Conway Planning Commission  
Staff Report

7:00pm • August 20, 2018 • 810 Parkway Avenue

**CONWAY CITY PLANNING DEPARTMENT REVIEW WINTERBROOK PHASE 3 PRELIMINARY PLAT**

**WINTERBROOK PHASE 3**

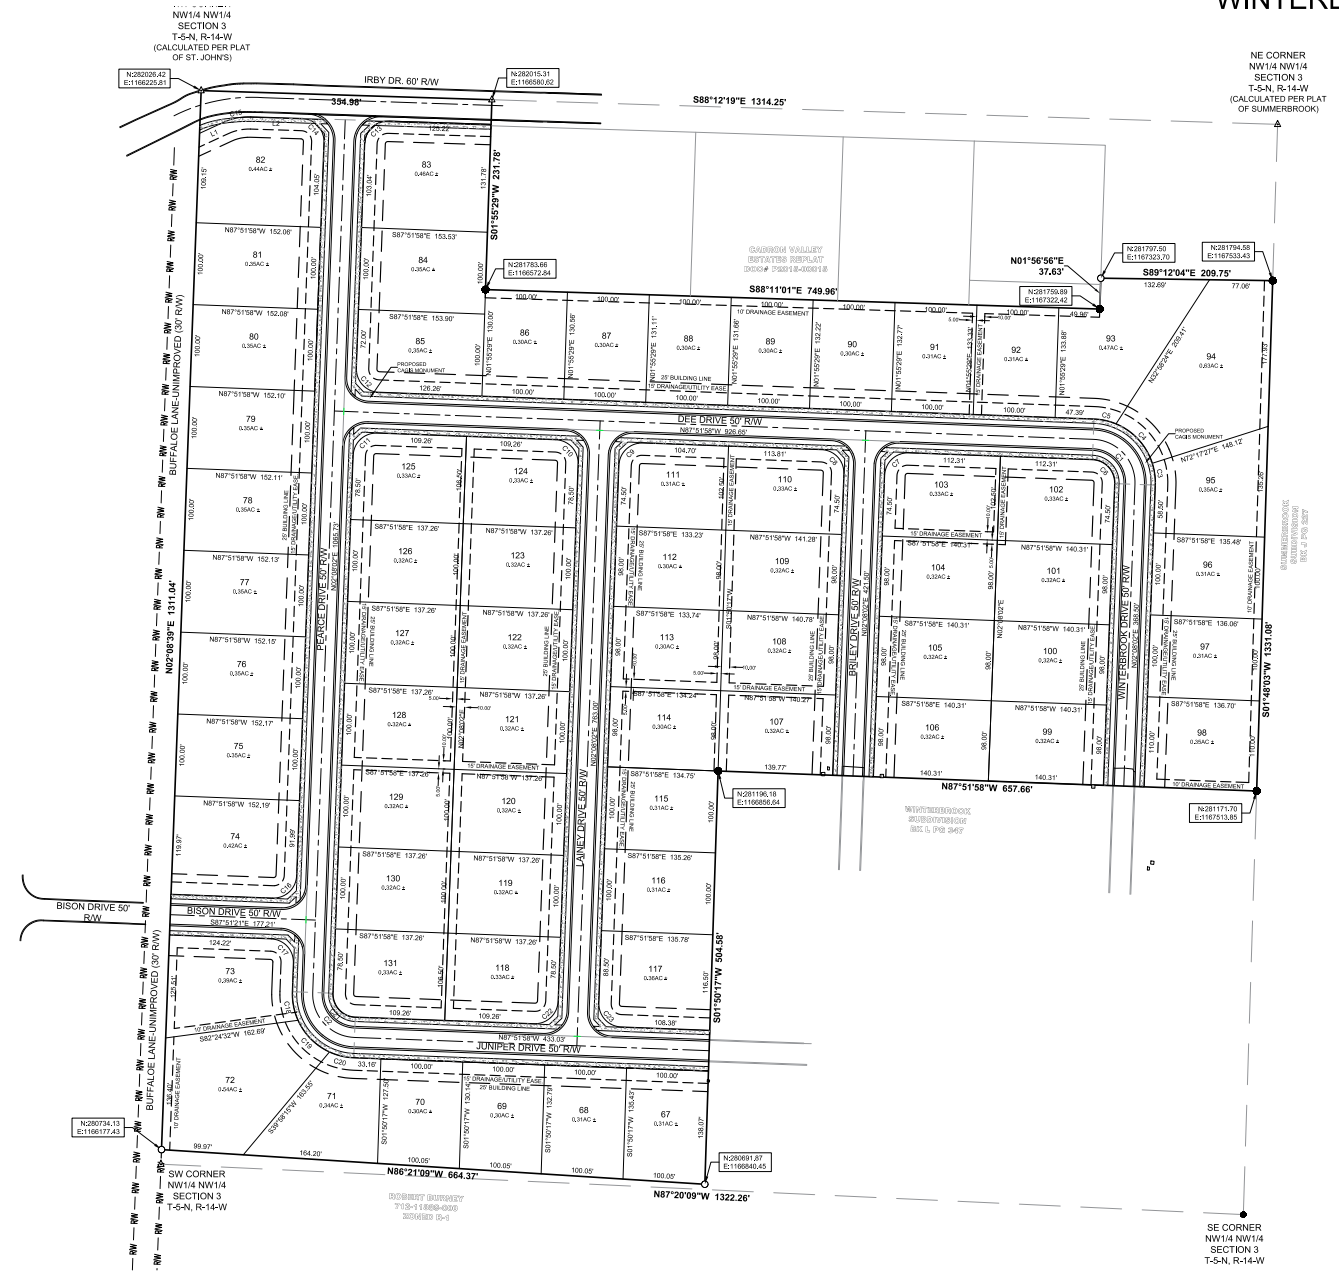
1. A legal description of the property with exact boundary lines, bearings and distances is needed.
2. If any portion of the land being subdivided is subject to flooding, the limit of such flooding shall be noted and the appropriate 100 year floodplain and/or floodway shall be identified.
3. The present zoning classification, if any, of the land to be subdivided/replatted and of the adjoining land contiguous to the boundary of the proposed subdivision/replat is needed. *Preliminary Plat approval is contingent upon rezoning to R-1.*

12. The proposed street layout should be integrated with the street system in the adjoining subdivisions. **Staff recommends developer be required to extend Bison Dr. West to connect to existing Bison Drive in existing subdivision. This will require improvements in ROW beyond owners boundary.**
13. Preliminary Plat approval is contingent upon Street and Engineering Review and approval of Street and Drainage Plans.

- 17. Corner lots shall be at least 75 feet in width at the building line. ***A variance has been requested for Lots 73, 85, 102, 103, 110 and 111, front lot lines to be less than 75' at the building line. Planning Commission Approves / Does not approve this request, or this condition must be corrected.***

Staff recommends the approval of the preliminary plat subject to the amended punch list.
